SERVICE BULLETIN ASM-007

Product: Antenna System Monitor

Subject: Firmware 2.10 Release

Calibration - Rx Port

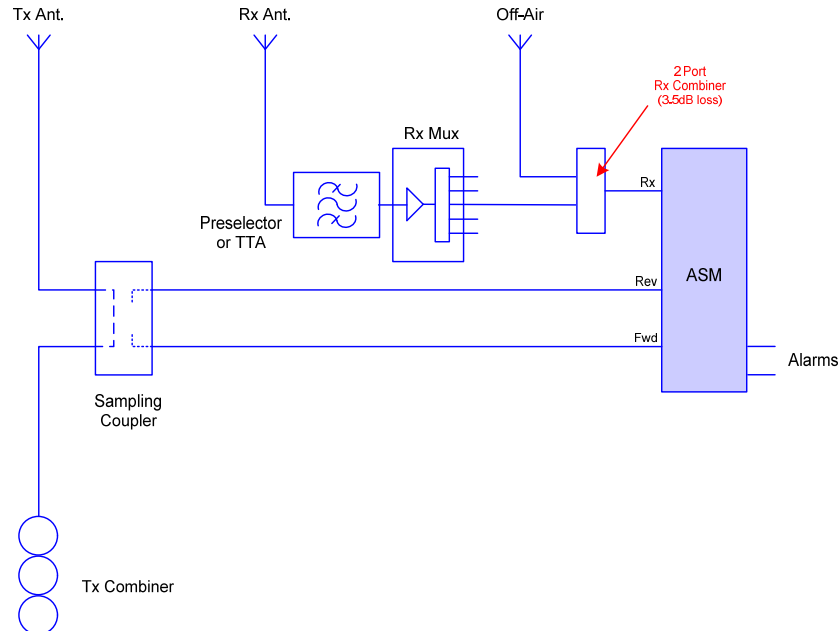
iii) Rx Calibration

This feature allows the inclusion of a value for an addition loss that may be introduced into the Rx path by a multi-input combiner when 2 or more Rx paths are being used in the ASM installation. This value is then added into the calculation of Rx Level and Antenna Isolation values.

Examples of using this feature include; when receive signals from more than one Receiver Multicoupler are being combined, or when both receiver multicoupler and external off-air signals are being monitored.

iv) Added History Graph selections

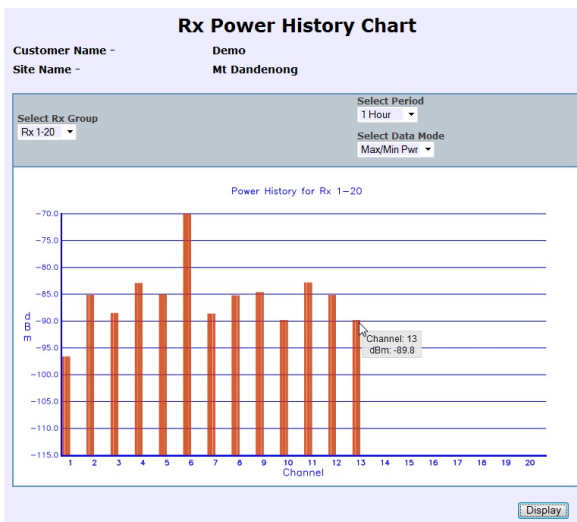
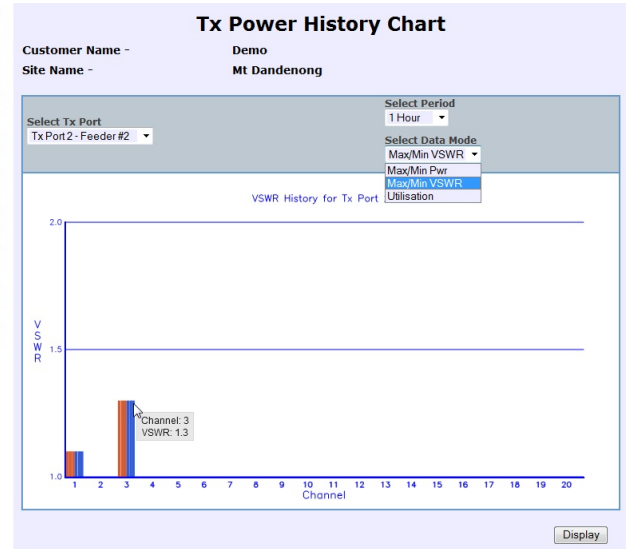
Additional History Graph selections are now available. Tx VSWR and Rx Level and Rx Utilisation displays may now be selected under the *History* menu.

Hovering the mouse near the top of a line will show the displayed value.

In these displays, only values that exceeded the entered threshold values are displayed.
